SERVICE BULLETIN

UTILITY TRAILER MANUFACTURING CO.

SB-14-015

REEFER FLOOR DRAIN KAZOO | SPECIFICATION FOR PRESSURE RELIEF SLIT

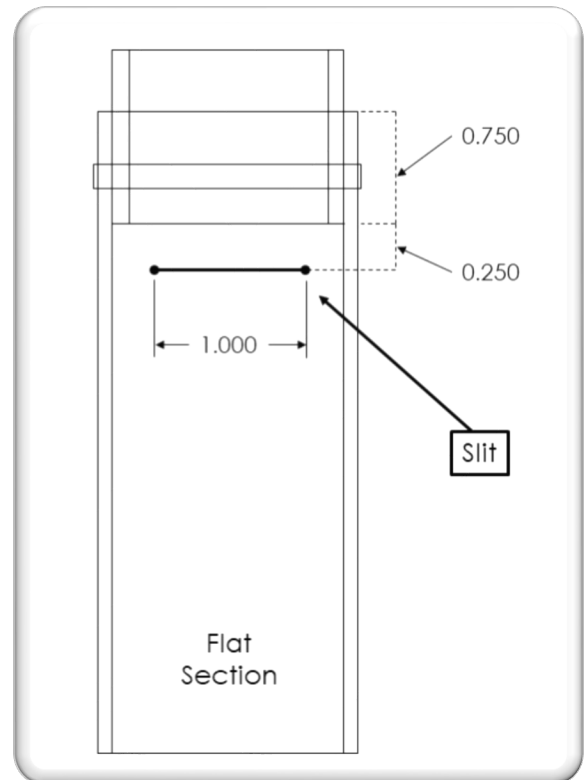
Whenever replacing floor drain kazoops in the field, use a sharp razor blade to add one 1" wide slit, located 1/4" below the bottom edge of the drain pipe and centered in the flat section of the kazoo as shown in the illustration. With a 3/4" overlap of the kazoo to the drain pipe, this works out to be 1" down from the top edge of the kazoo.

A shift in temperature of a Utility reefer unit can cause pressure change within the tightly sealed trailer box if the kazoops freeze or become clogged. The slit added to the drain kazoo acts as a pressure relief valve, allowing the pressure inside the trailer to equalize with the pressure outside the trailer.
